MAINE TURNPIKE AUTHORITY

ADDENDUM NO. 1

CONTRACT 2014.14

BRIDGE REPAIRS

SECTION A-A - SHEET 26 OF 40
1/2" = 1'-0"

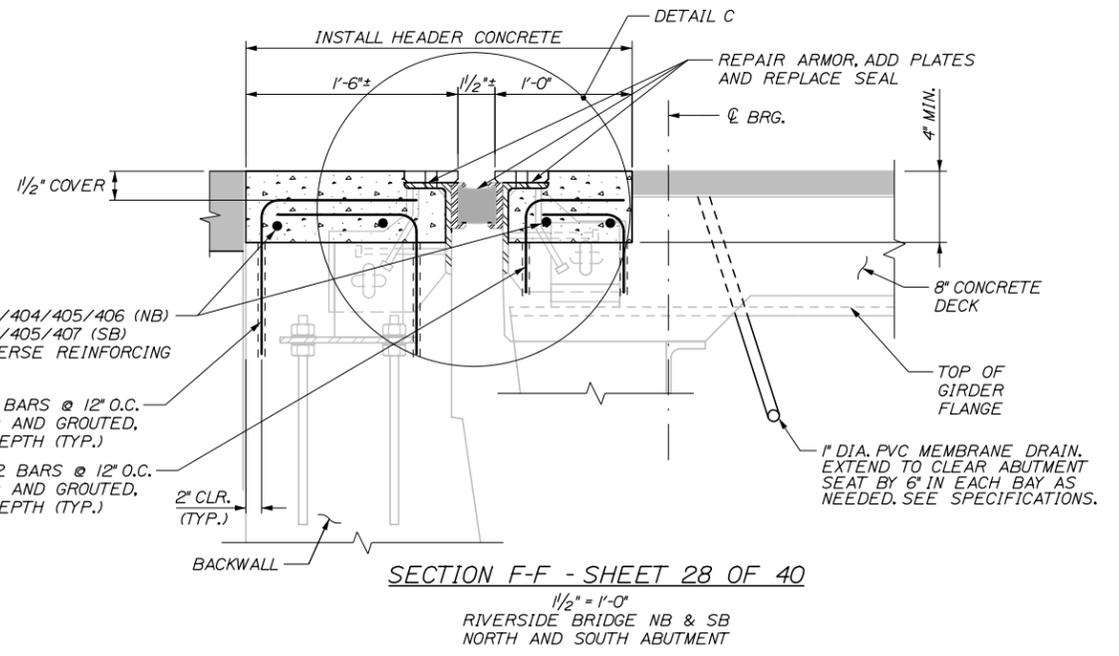
Sheet 26 of 40, Section A-A shall be deleted and replaced with Section A-A included in this addendum.

SECTION F-F - SHEET 28 OF 40
1/2" = 1'-0"
RIVERSIDE BRIDGE NB & SB
NORTH AND SOUTH ABUTMENT

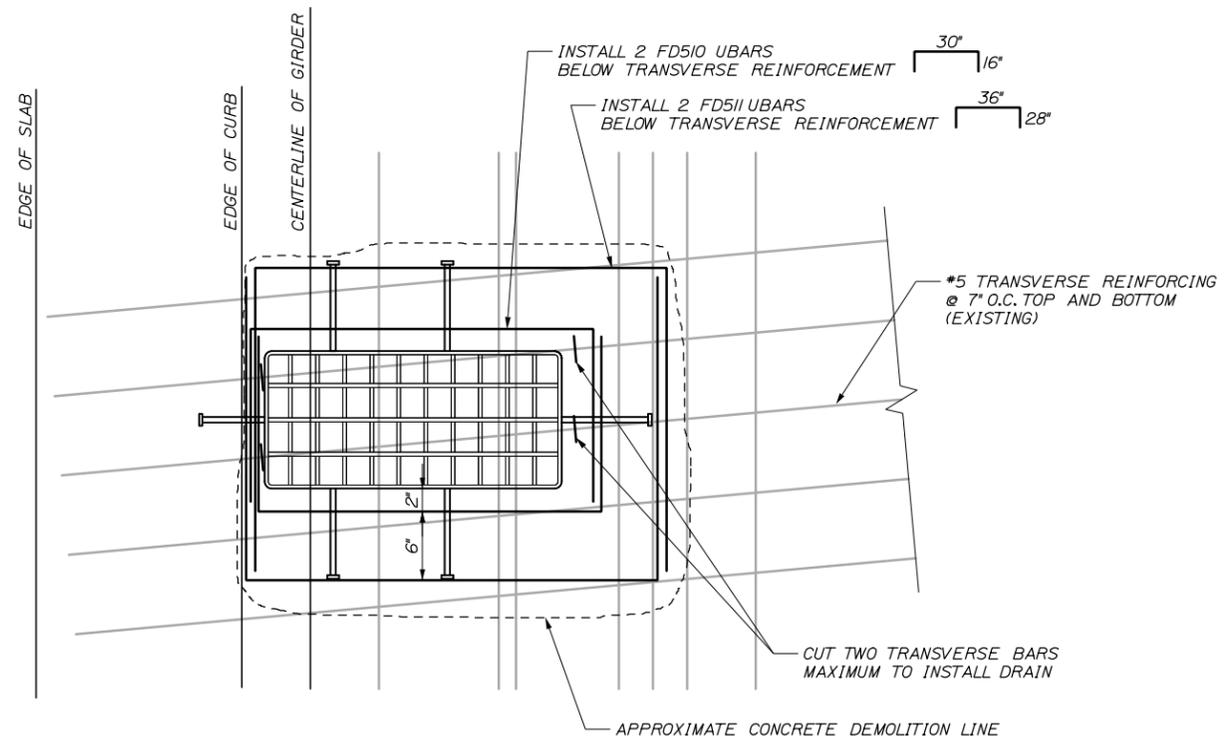
Sheet 28 of 40, Section F-F shall be deleted and replaced with Section F-F included in this addendum.

Question 8: There are no rebar call outs on section F-F on sheet 28 of 40.

Answer: See revised section F-F included in this addendum.

REINFORCING STEEL

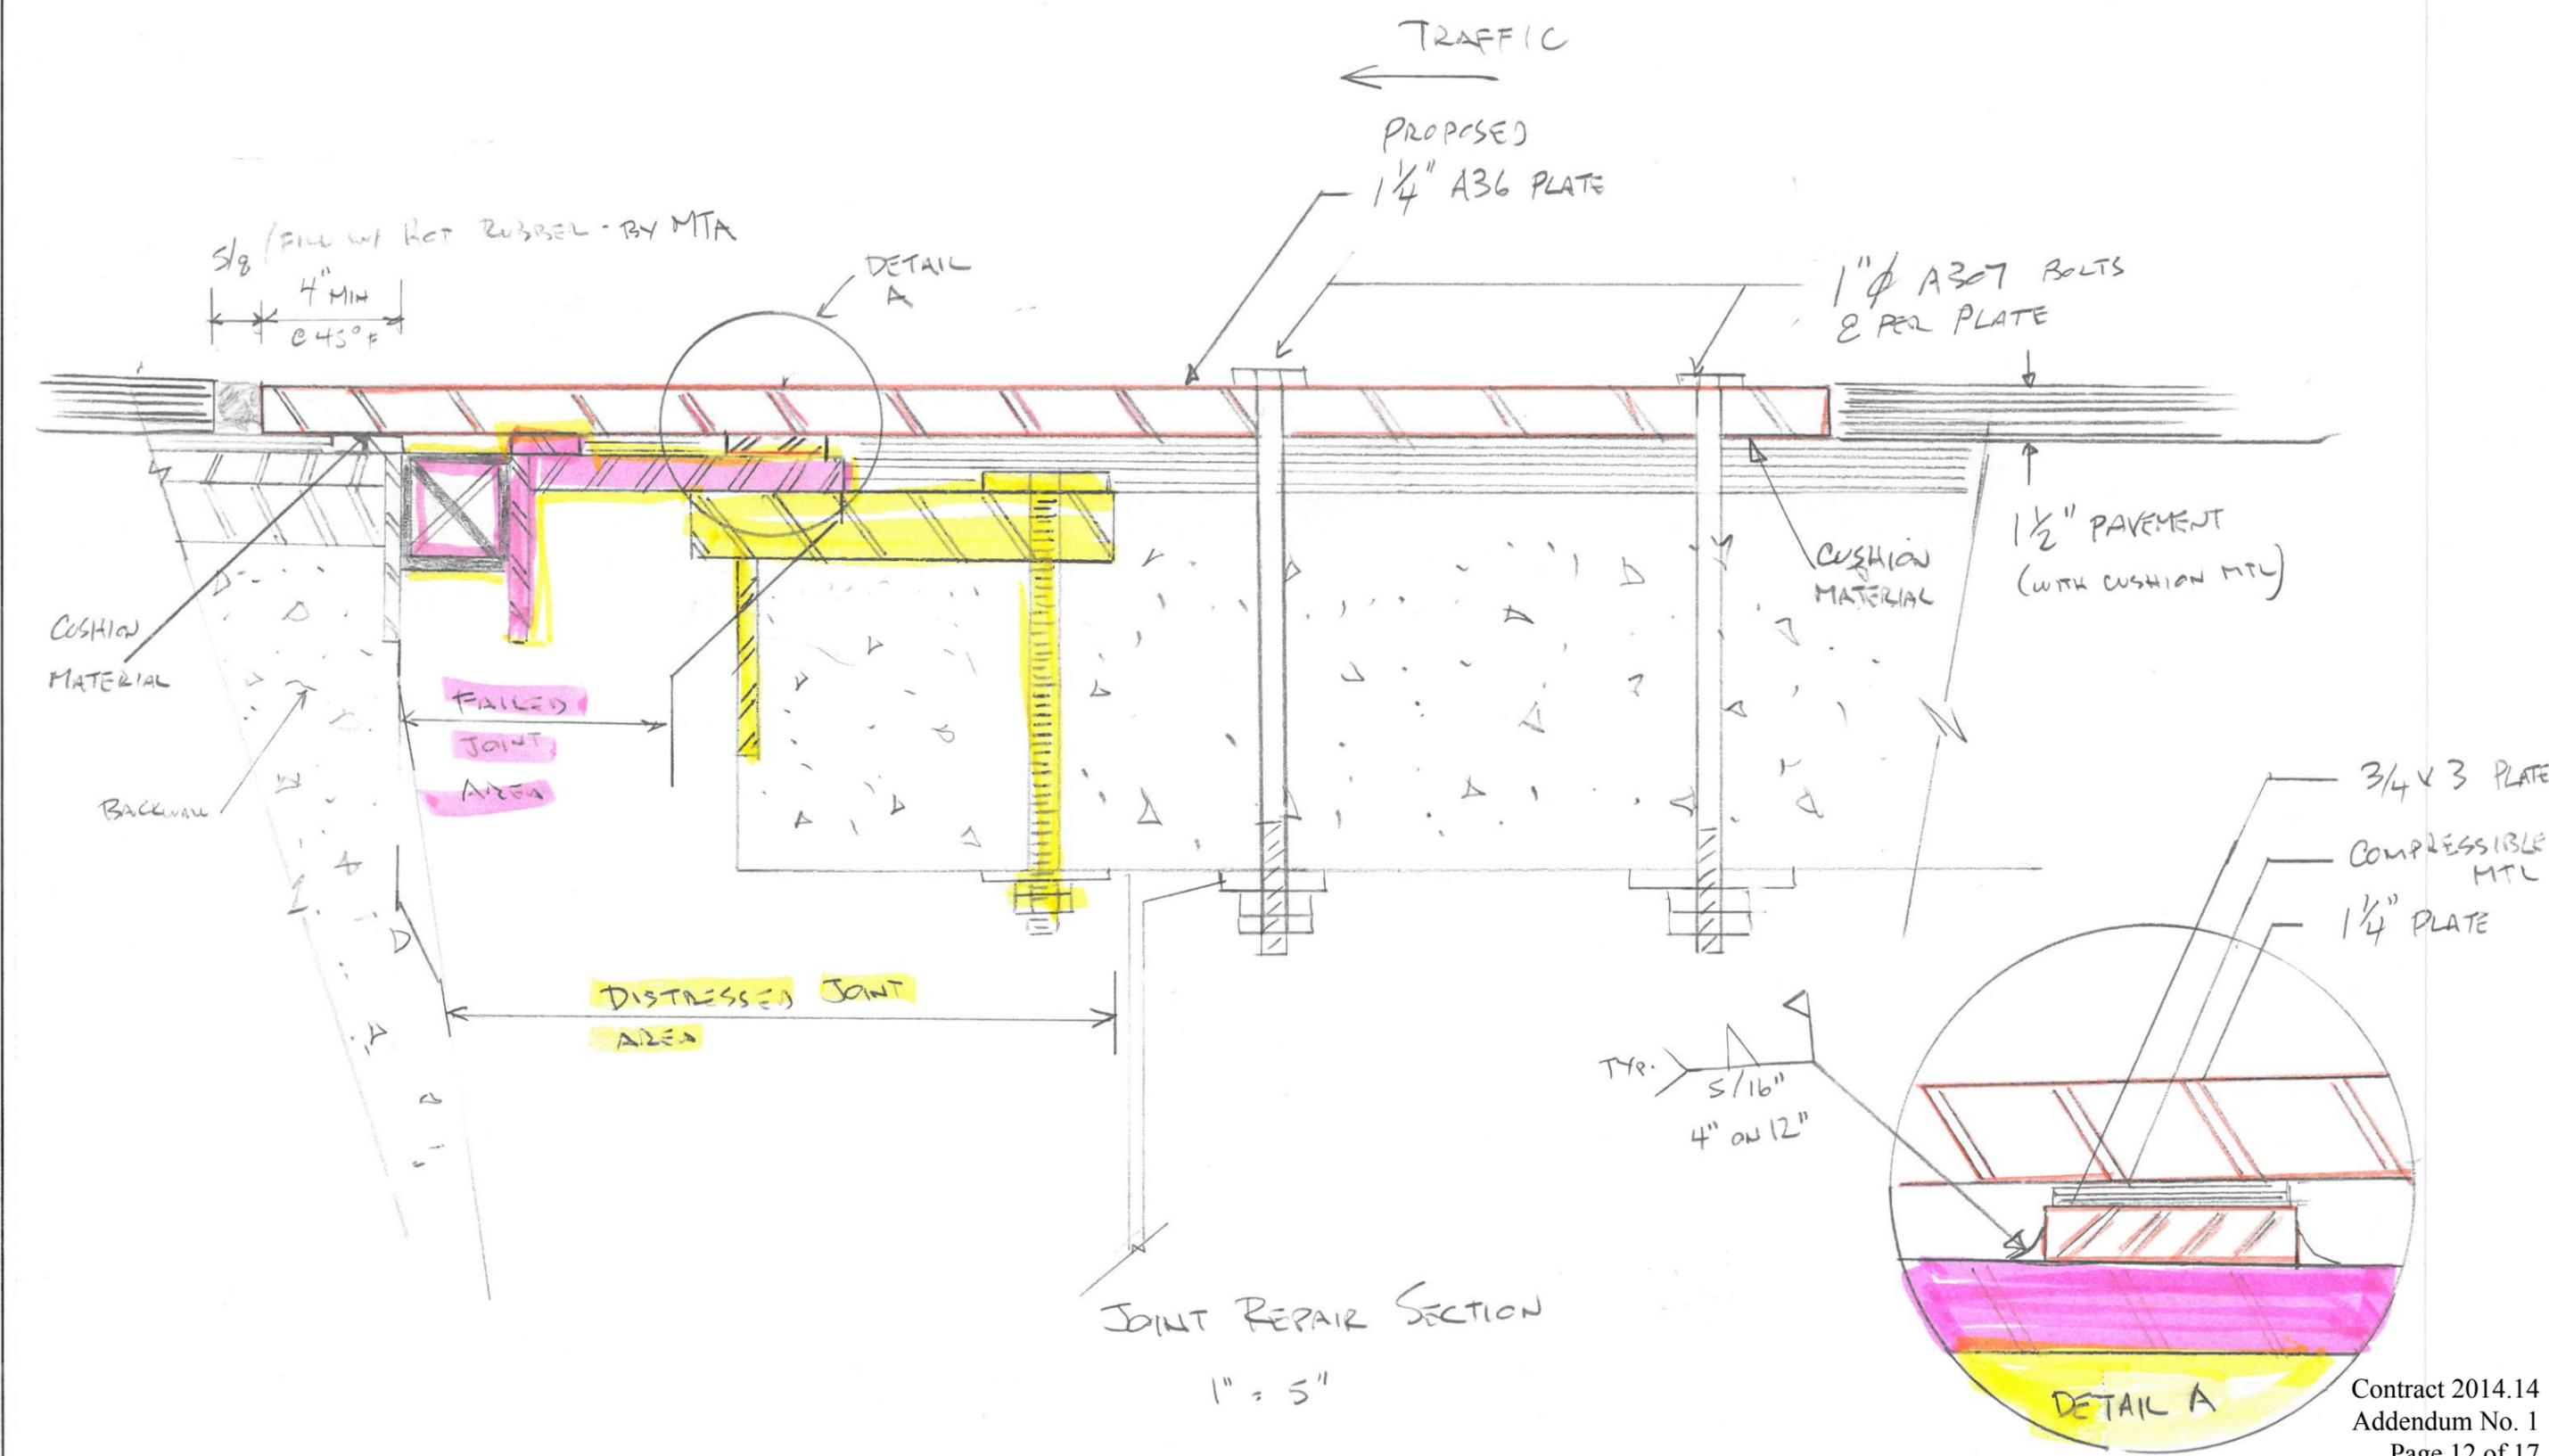
Reinforcing steel locations can be determined from the Reinforcing Schedule.

Question 7: Why is reinforcing steel incidental instead of a schedule provided and paid for per pound?

Answer: The Authority has provided a reinforcing steel schedule, and reinforcing steel pay item under this Addendum.

Plate Phasing-Removal

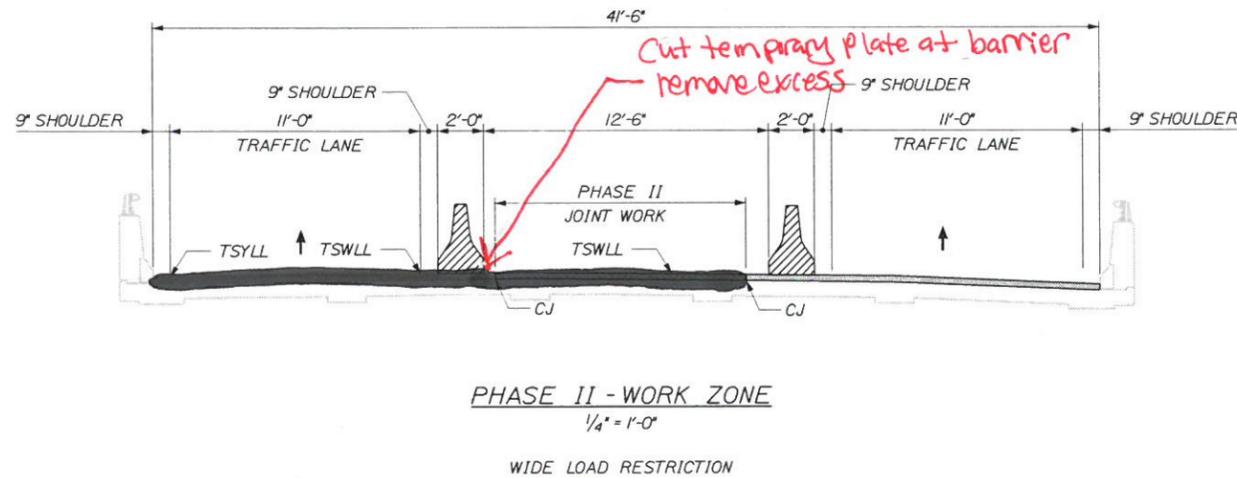
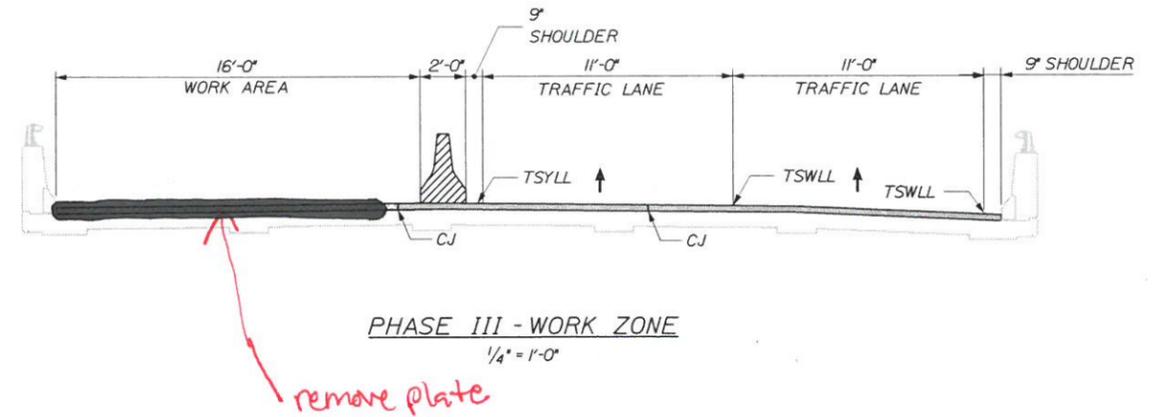
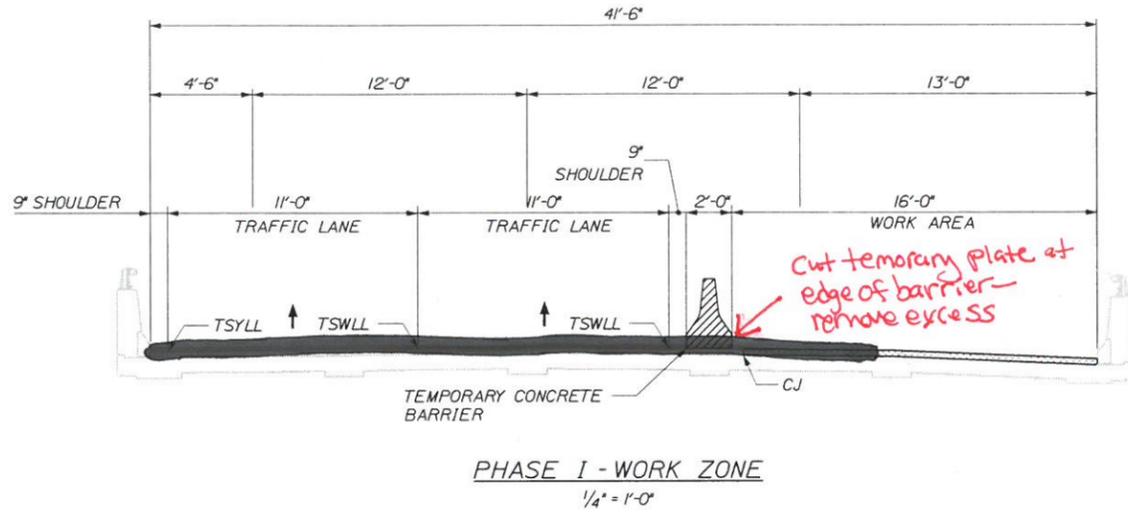
Question 1: Will the addendum address maintenance of the emergency repair.

A copy of the Emergency Repair Solicitation, and a sketch showing the plate demolition as the work progresses, are attached for the bidders' information.

Answer: Yes, this addendum addresses maintenance of the emergency repair. See the Special Provision Maintenance and Removal of Temporary Roadway Plating, included in this addendum, for the work required due to the installation of the temporary steel plates at Forest Avenue southbound.
